Analysis of Comments Received on San Vitores Road Flood Mitigation Project

Public Law 30-228 appropriated proceeds from the Hot Bond “for resolution of the San Vitores flooding caused by storm water runoff along San Vitores Road north of the Fujita Pump Station by collecting and removing storm runoff via transmission to the Fujita Pump Station to be discharged at a suitable location.” After evaluation of alternatives to satisfy the Law’s requirements, the Bay Outlet option was selected for design and construction and taken through the completed public/agency comment phase. Some members of the public and government agencies have expressed concerns with the proposed Bay Outlet solution. The objective of this communication is to provide a summary of project issues and options so a viable solution can be developed. A description of the project tasks and agencies contacted is attached as Exhibit A.

Channel Options

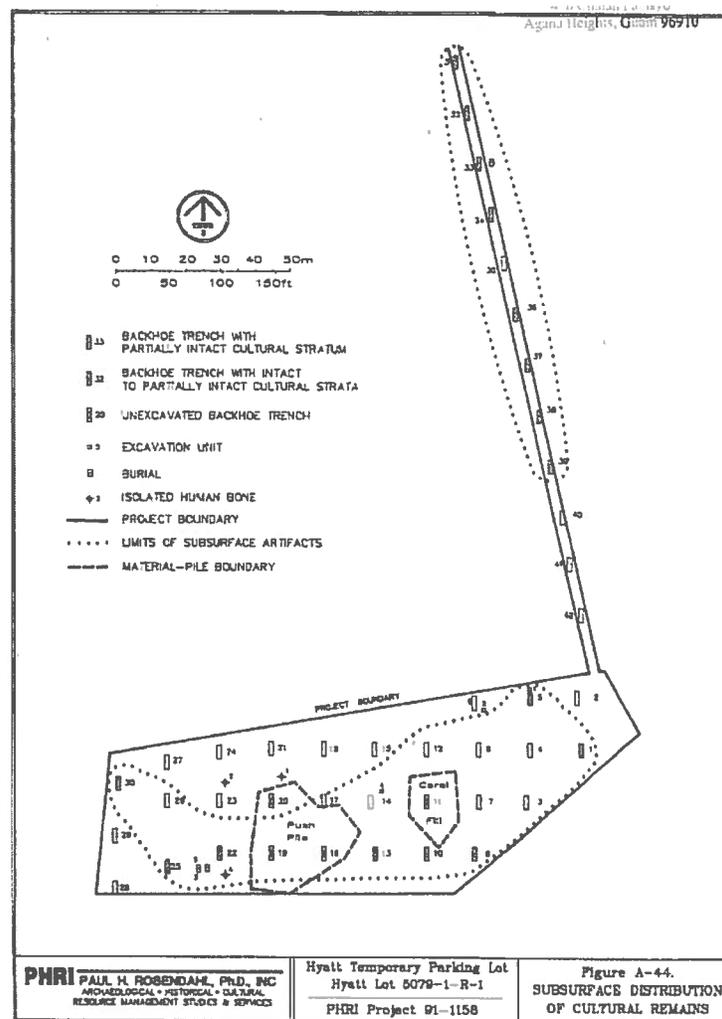
A review of these archived materials indicates that there are intact deposits below and along the road. The potential for the culvert option to impact these deposits remains high, especially considering the extent of the excavations needed to accommodate the culverts.

A 1993 archaeological project investigated the property the Fujita Ponding Basin currently occupies as well as a corridor extending seaward from it approximately 185 meters long that was parallel to and east of Fujita Road. The corridor appears to have tested the area slated for the channel. However, as with so many of the maps included with PHRI reports they float in space and it is difficult to precisely locate the project on either a topographic map or air photo. See the project map provided below.
